**DEVIATION REQUEST
AND DECISION FORM IN
ASSOCIATION WITH
A REQUEST FOR A PUD
MODIFICATION FROM
THE ECM**

Project Name : MEADOWBROOK PARK

PROPOSED MEADOWBROOK PARK PUD PRIVATE ROAD CROSS SECTIONS

STANDARD COUNTY URBAN LOCAL (LOW VOLUME) CROSS SECTION:

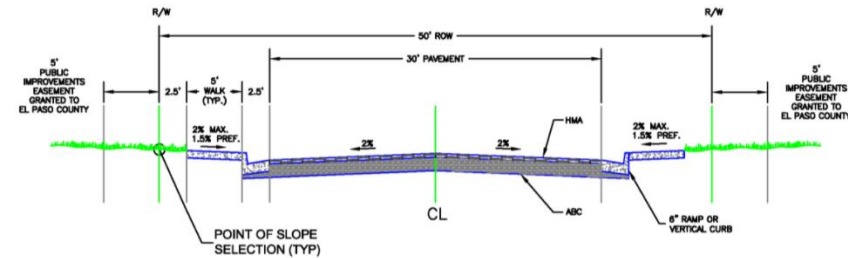
Deviations Requested from Urban Local (Low Volume) Roadway Section:

- Change of pavement width from 24 feet EOP (Edge of Pavement) to EOP to 20 feet EOP to EOP
- Change of crowned pavement to superelevated roadway section for certain portions of roadway to facilitate drainage
- Change of lane width from 12 feet to 10 feet

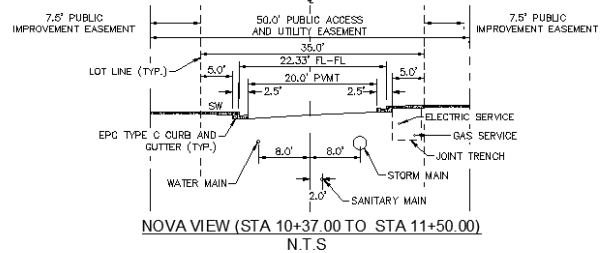
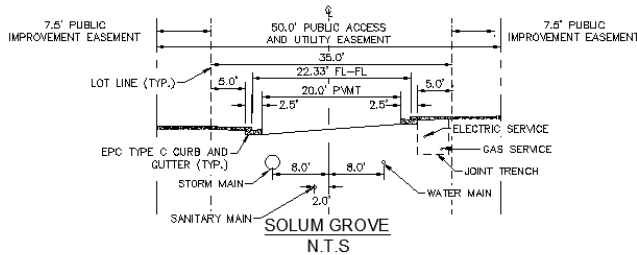
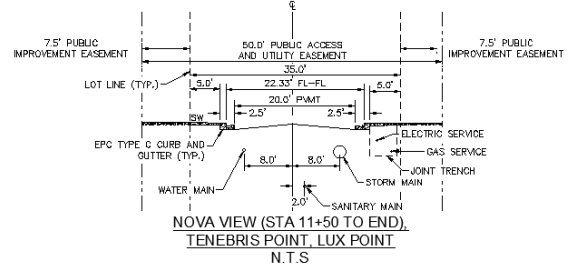
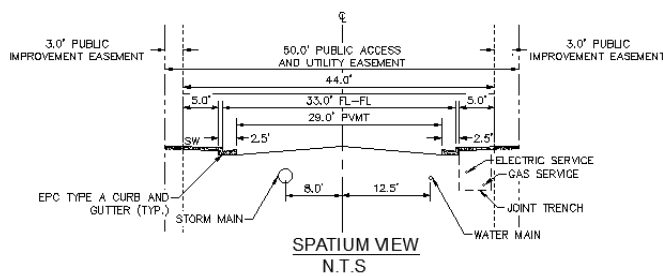
Deviations Requested from Urban Local Roadway Section:

- Change of pavement width from 30 feet EOP (Edge of Pavement) to EOP to 29 feet EOP to EOP
